CERTIFICATE OF APPROPRIATENESS PLACARD

Remove existing shingle and standing seam metal roofs; install standing seam metal roofs; replace foundation wall; replace concrete front steps; remove side screen door

616 Wills Forest St

COA-0022-2022

**SENTRIGARD**
METAL ROOFING SYSTEMSwww.sentrigard.com

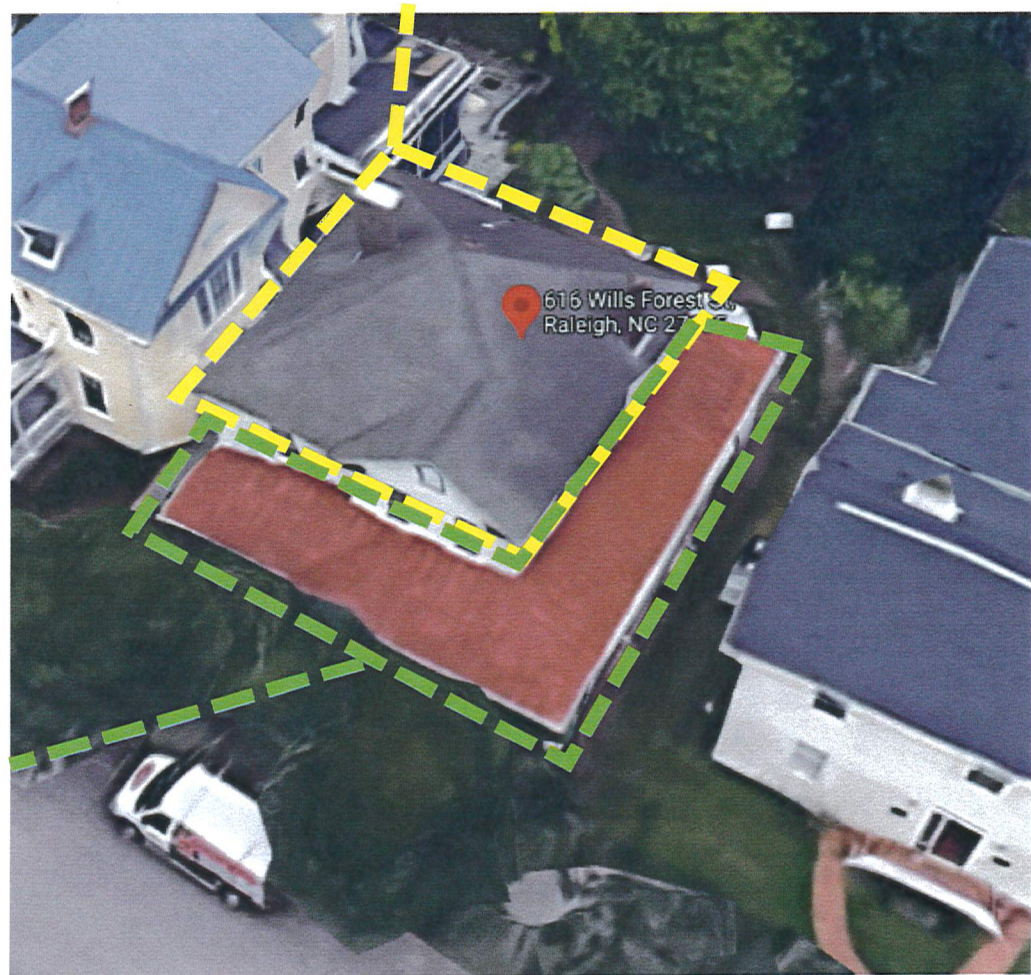
Provide standing seam metal roof specifications. The pan width of the existing porch roof should be matched. Staff can approve 15-20" flat pans (no striations), about 1" vertical seams, and a very low profile ridge cap if applicable.

- We are currently working with a roofing contractor and will have cut sheets over to you shortly. Regardless, we will ensure that the proposed SS metal roof has 15-20" flat pans (no striations), about 1" vertical seams, and a very low profile ridge cap.

① EXISTING EAST ELEVATION
1/8" = 1'-0"

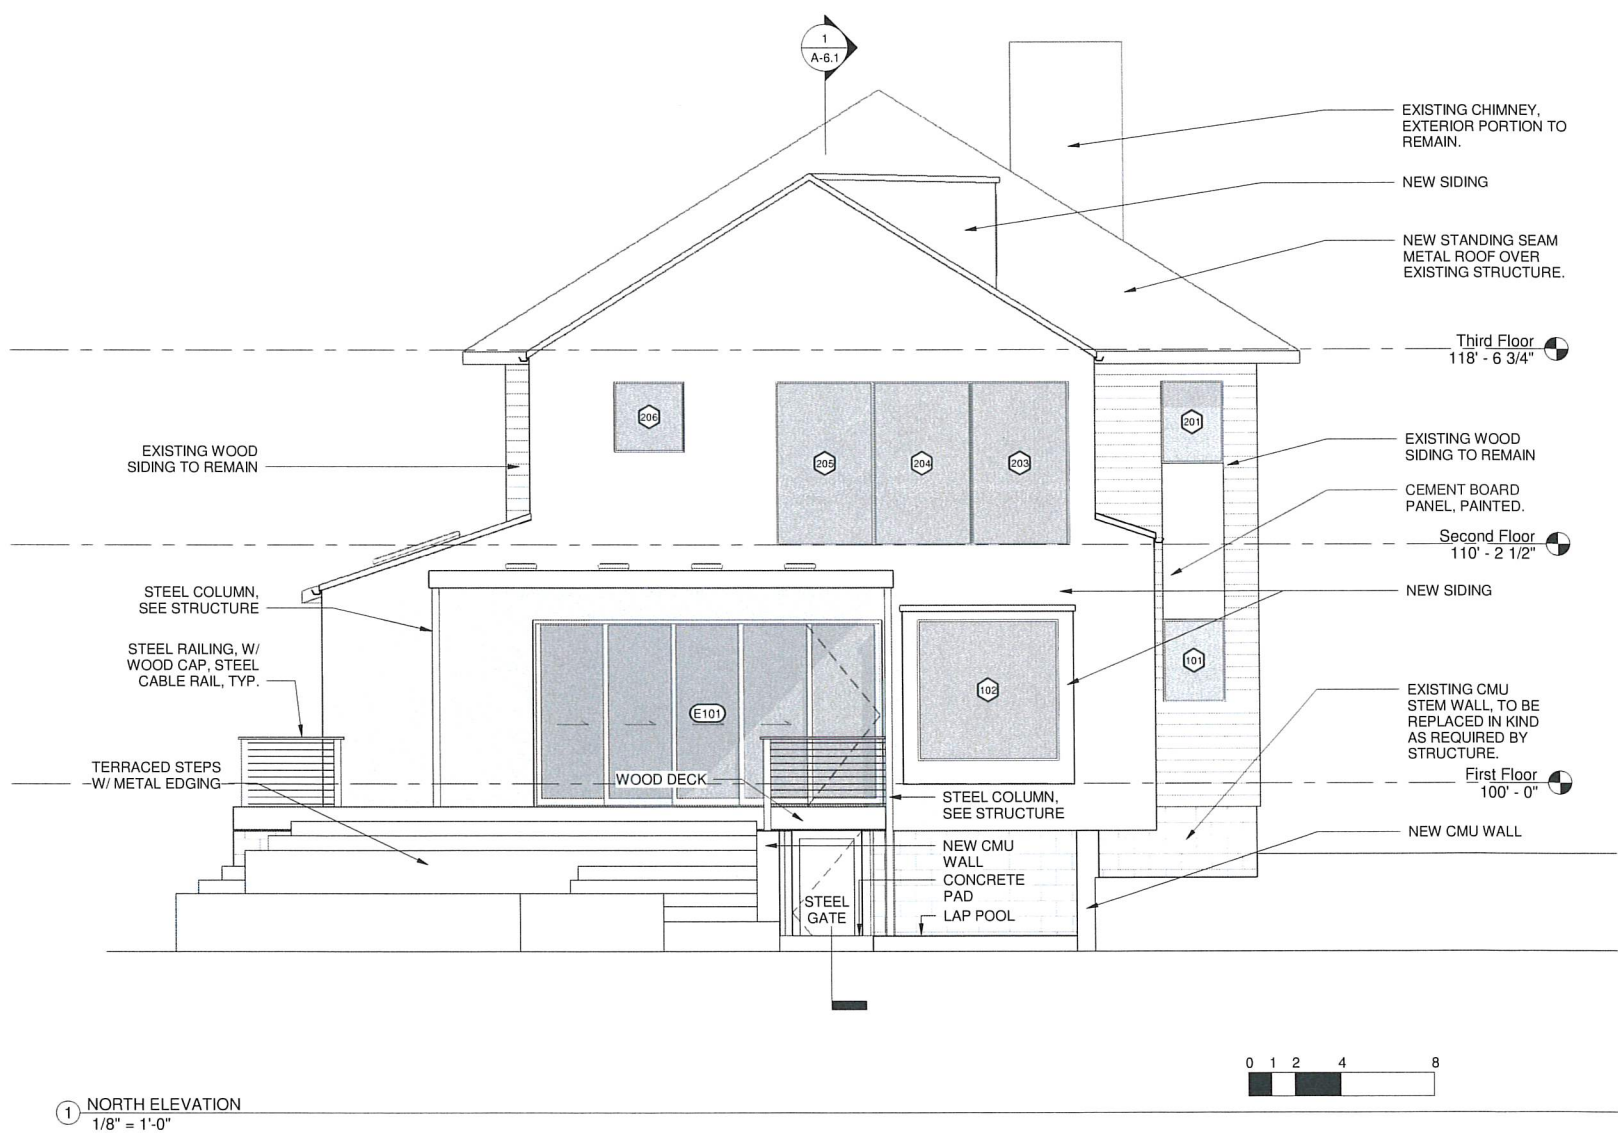
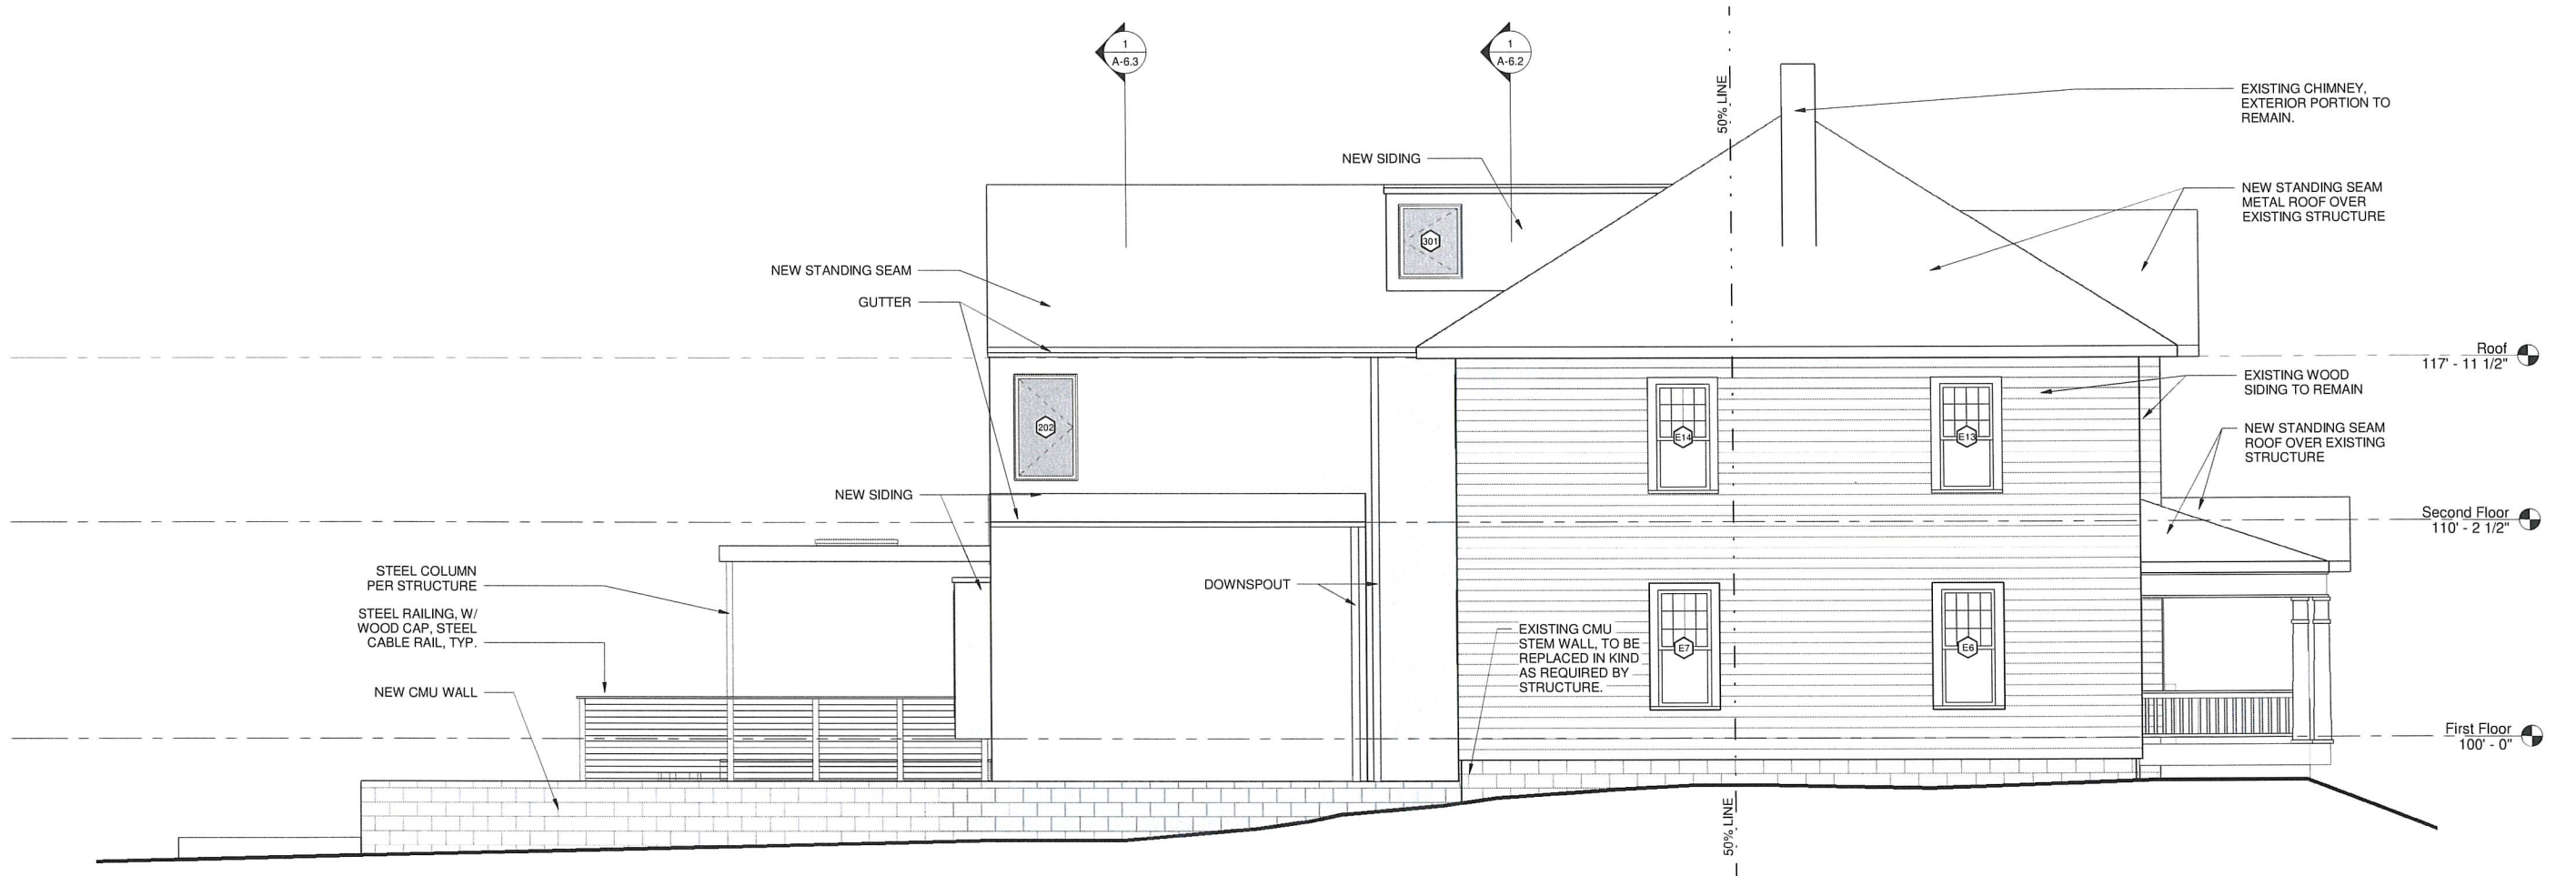
Provide scaled existing and proposed east elevation dwgs showing the existing door and proposed window with siding infilled

- The elevation drawings is included in the revised drawing package. However, as mentioned above, the door will now be retained and made inoperable.
